**TOWN OF MANCHESTER
PLANNING AND ZONING COMMISSION**

May 20, 2024
7:00 P.M.

RE: Vessel Technologies
Zoning Regulation Amendment (REG-0003-2024)

RE: Trivik Builders, LLC – 27 Lillian Drive
PRD Detailed Site Plan Modification (PRD-0001-2024)

SITE LAYOUT PLAN
 27 LILLIAN DRIVE
 PREPARED FOR
TRIVIK BUILDERS, LLC
 MANCHESTER, CONNECTICUT
 (FORMERLY 321 OAKLAND STREET AND 27 LILLIAN DRIVE)

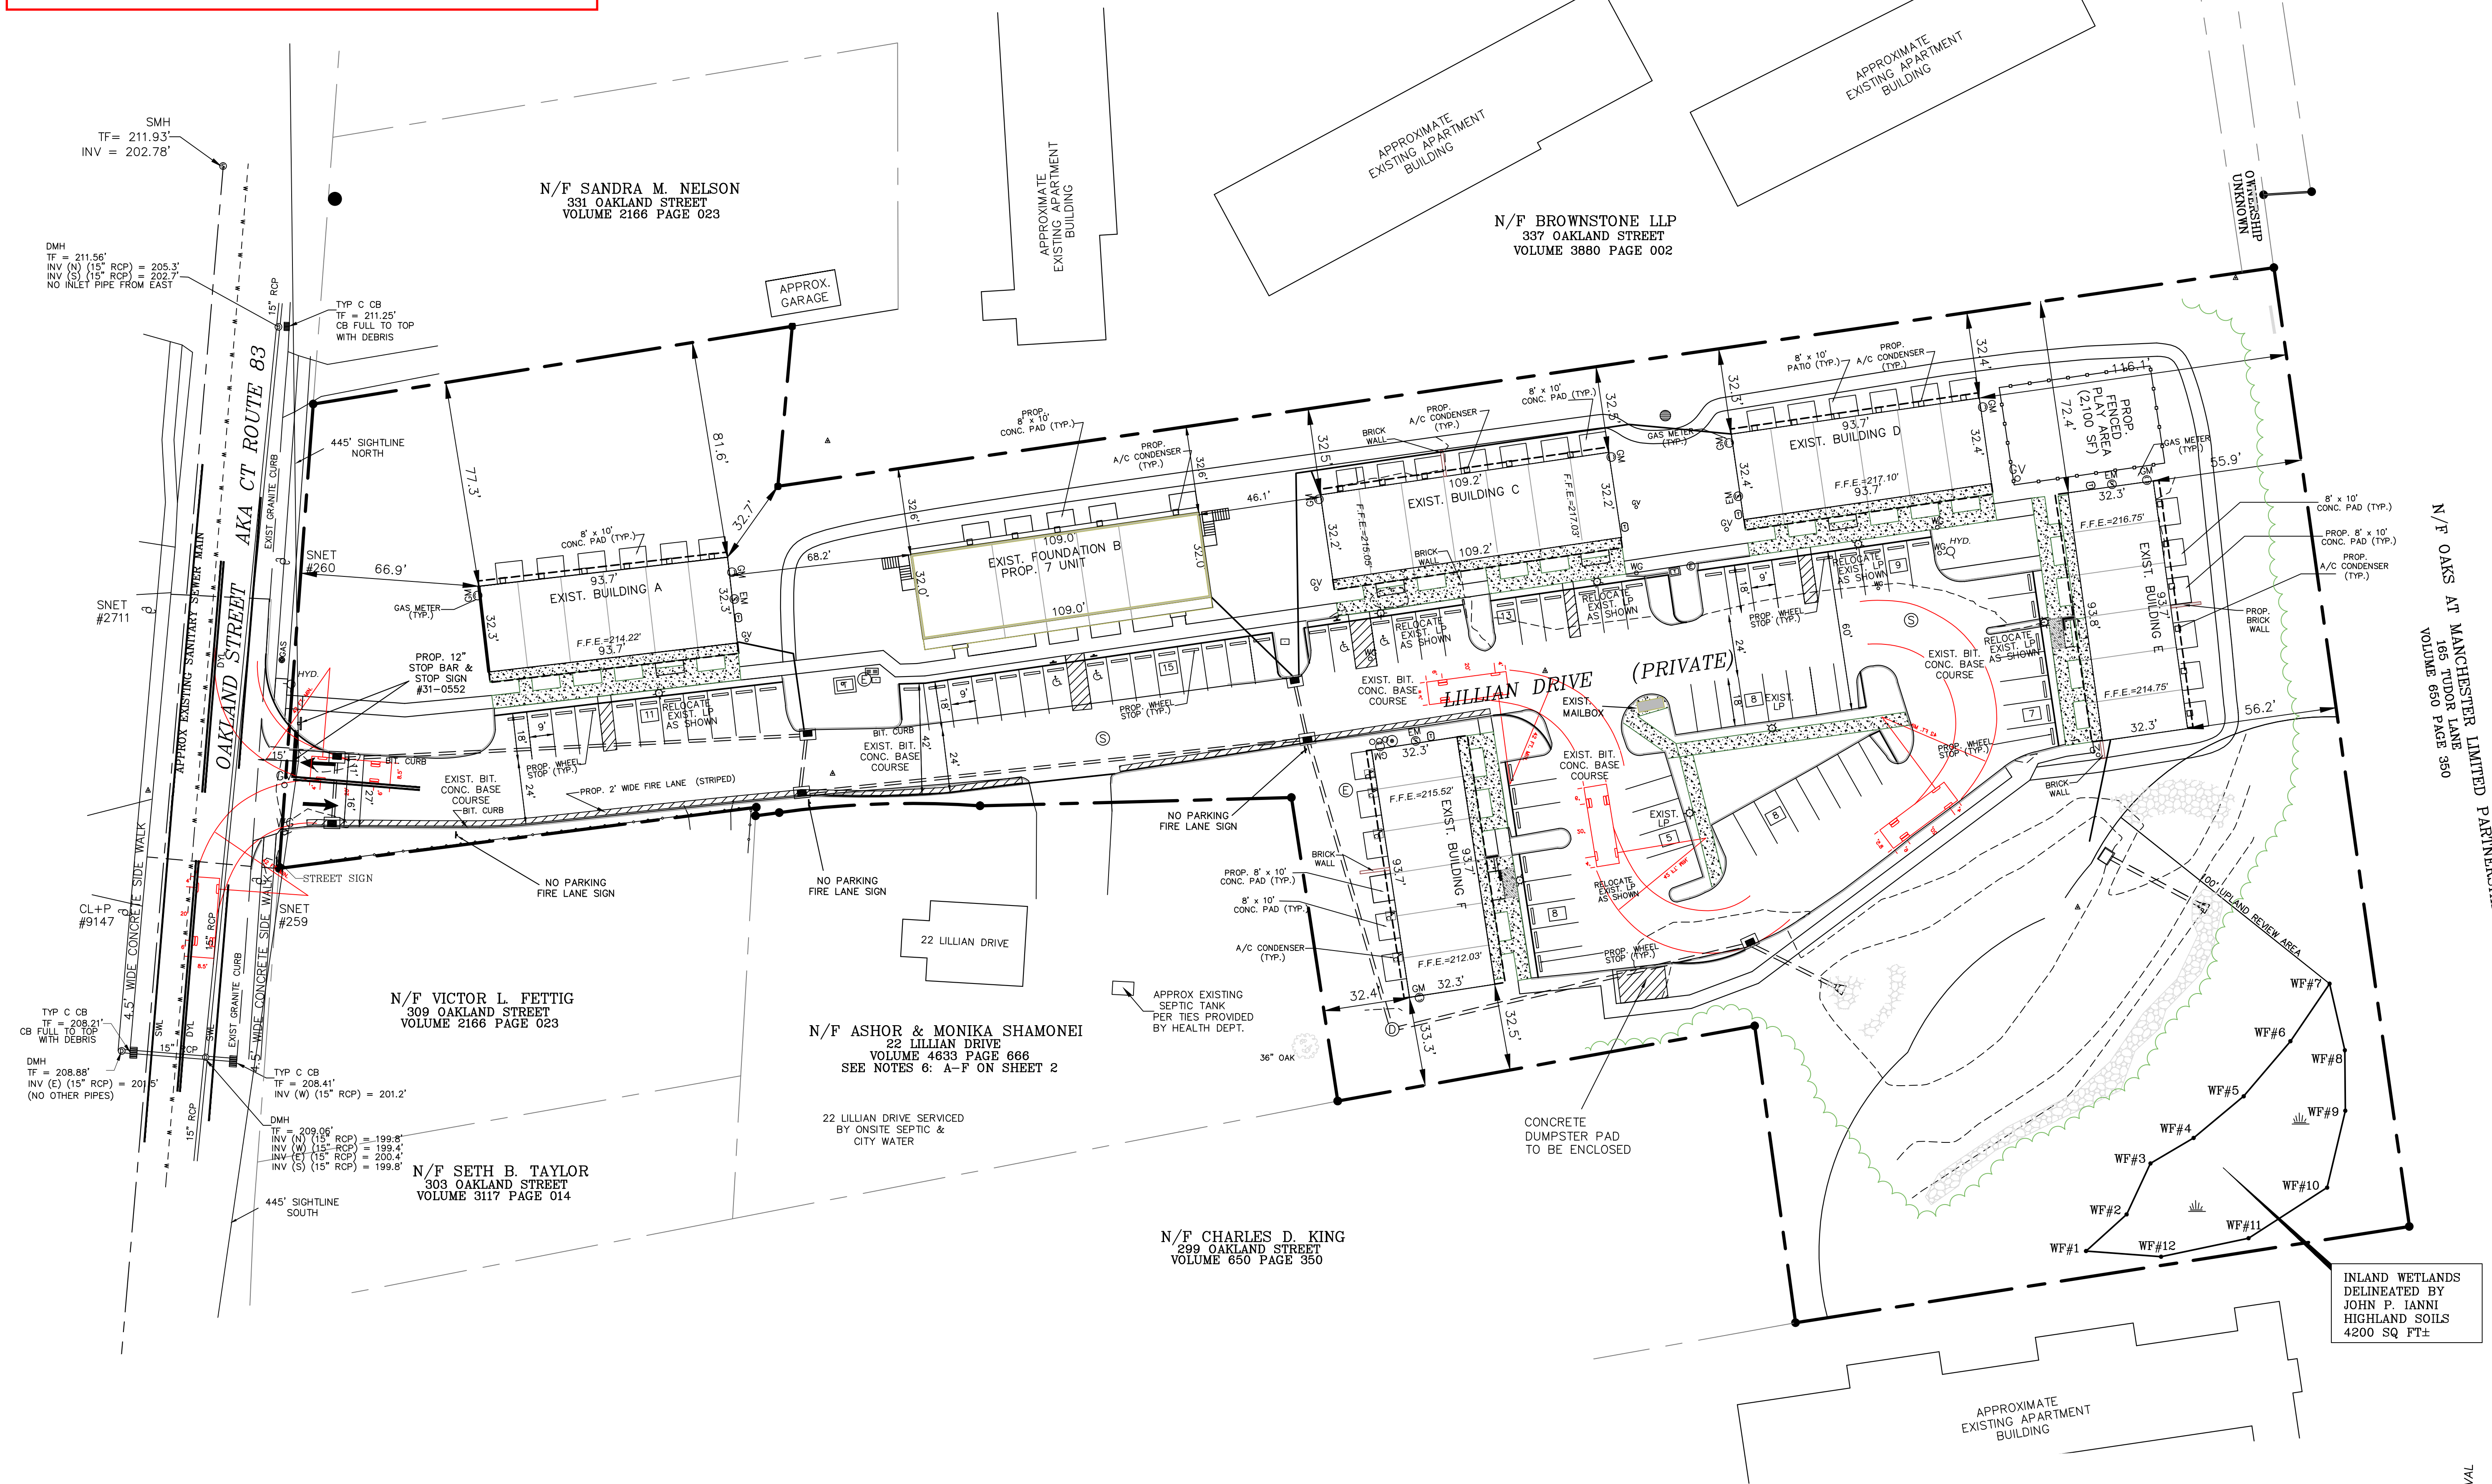
In response to staff concerns about safety and accessibility impacts of some of the deviations from the previously approved plans, the applicant is proposing additional modifications to correct those issues. The proposed solutions to the most significant issues are highlighted on sheet SP-2 of the attached plan set.

<i>Deviation from approved plans</i>	<i>Proposed solution</i>	<i>Staff comment</i>
No curbing and no grass strip between parking and sidewalks in front of buildings	A 2-ft. grass strip is reintroduced by pulling the edge of pavement away from the sidewalks. The applicant states that minimum parking stall length and 24-ft. drive aisle width are maintained. The applicant states that curbing cannot be reintroduced due to grading issues, but concrete wheel stops are proposed to prevent vehicles from pulling too far forward.	The combination of a 2-ft. grass strip between the parking and sidewalk and concrete wheel stops alleviates the primary safety concern that staff initially had. This solution is acceptable to staff.
Light poles located within sidewalks	While the light poles were initially proposed to remain within the sidewalks, the applicant has updated the plan to relocate the light poles into the 2-ft. grass strip.	This solution alleviates the initial concern and is acceptable to staff.

<p>Changes to drive aisle curbs causing possible conflict points for large emergency vehicles</p>	<p>The updated plan includes removal and reinstallation of curbing at the two identified potential conflict points, and the applicant states that a 24-ft. drive aisle width will be maintained throughout the site.</p>	<p>This solution alleviates the initial concern and is acceptable to staff.</p>
<p>Unapproved stormwater infrastructure installed</p>	<p>No change proposed.</p>	<p>Although it is not ideal for the recreational walking path to be forced to jog around the yard drain between Buildings C and D, it does not create a safety or accessibility issue, and is therefore not a major concern to staff.</p>
<p>Brick retaining walls installed within sidewalks in front of Buildings C, E, and F</p>	<p>The plan has been modified to move all retaining walls out of the path of the primary sidewalk. At Building C, the sidewalk will be regraded so that no wall or stair is necessary. At Building E, the retaining wall will be moved into the landscaped island and the sidewalk will be regraded so that no stair is necessary. At Building F, the retaining wall will be moved into the landscaped island. A stair is still necessary here, but it has been moved out of the main sidewalk, and is instead located at the entry sidewalk leading to one of the units. The third unit from the left (when facing the front of the building) will have two (2) steps down at the approach to its entrance, but the main sidewalk will have no steps. The applicant has provided an elevation sketch showing the proposed sidewalk grading in front of Building F.</p>	<p>The proposed solution is acceptable to staff because the main sidewalk will be clear and not require steps.</p>

Proposed modifications with solutions to staff concerns noted

Proposed modifications to Building B

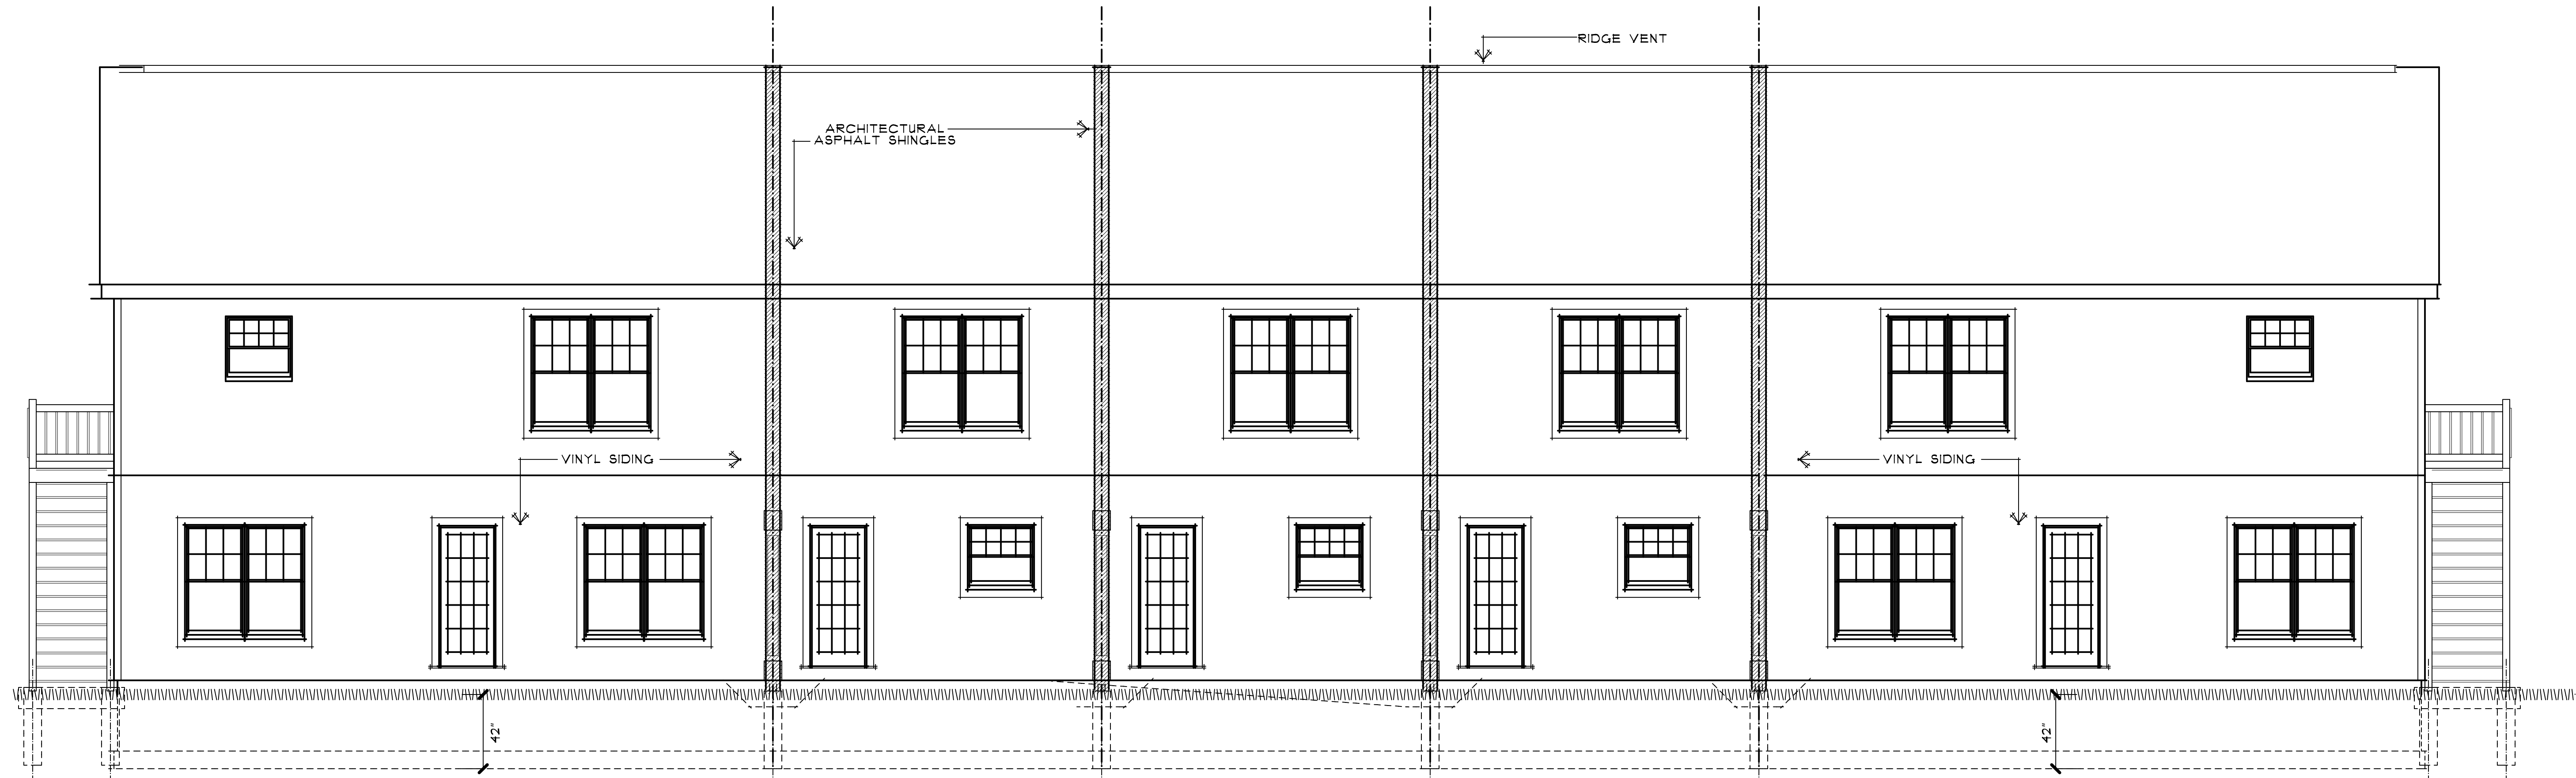
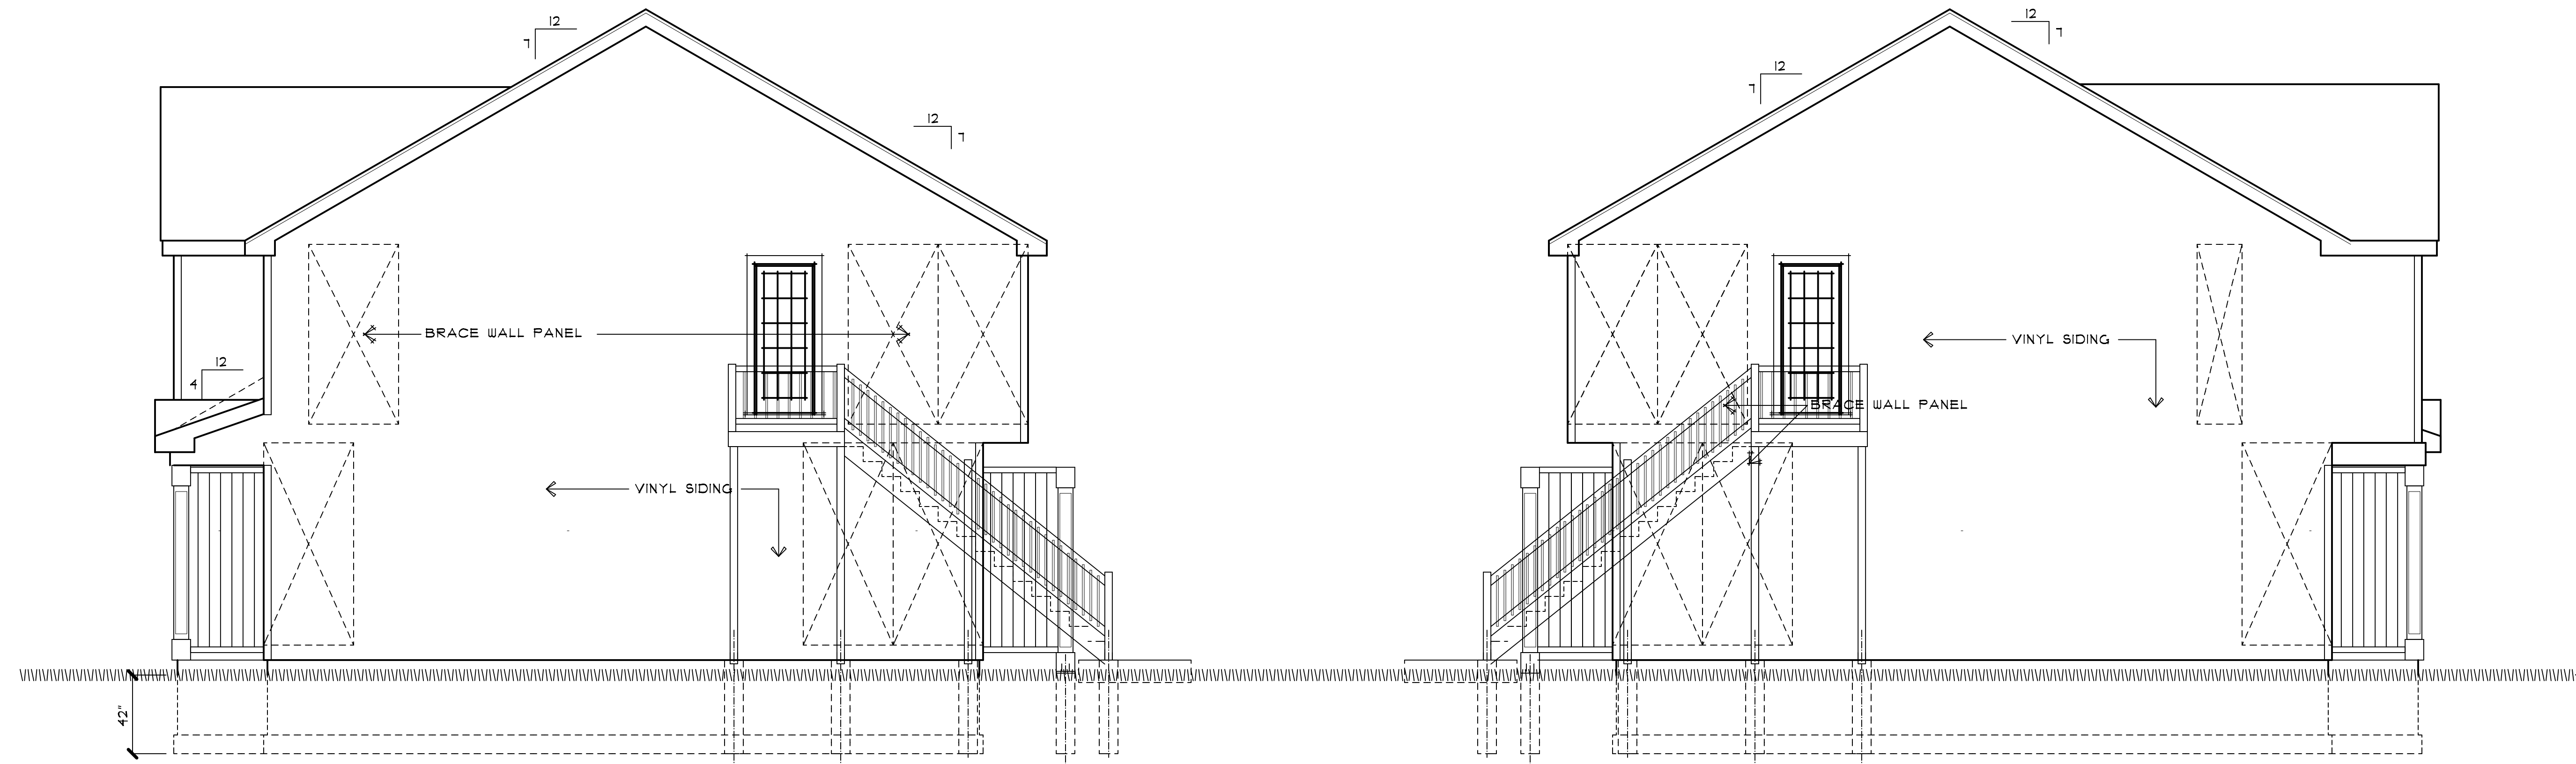
- Proposed Building B will include (2) ADA accessible units. Due to the revised building design, this will result in (2) non-ADA units being entirely on the second floor and will require exterior staircases on the end of the building as means of secondary egress.
